Technical Bulletin - TB0026

TCP/IP Module Upgrade for TDSi's MICROgarde Controllers

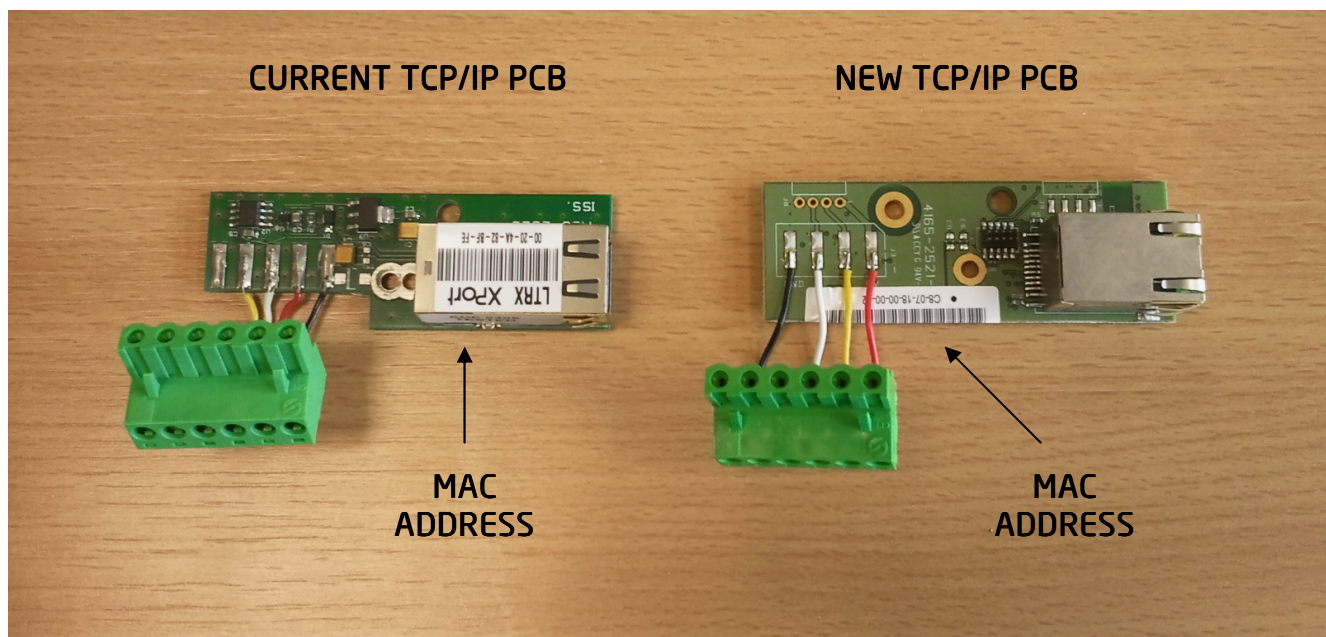
- The old PCB was fixed to the chassis with a Self Tapping Screw.
- The new PCB is fixed in the same manor, but requires a Plastic Washer between the PCB and the Chassis.
- The Self Tapping Screw and Plastic Washer is supplied with the Kit.
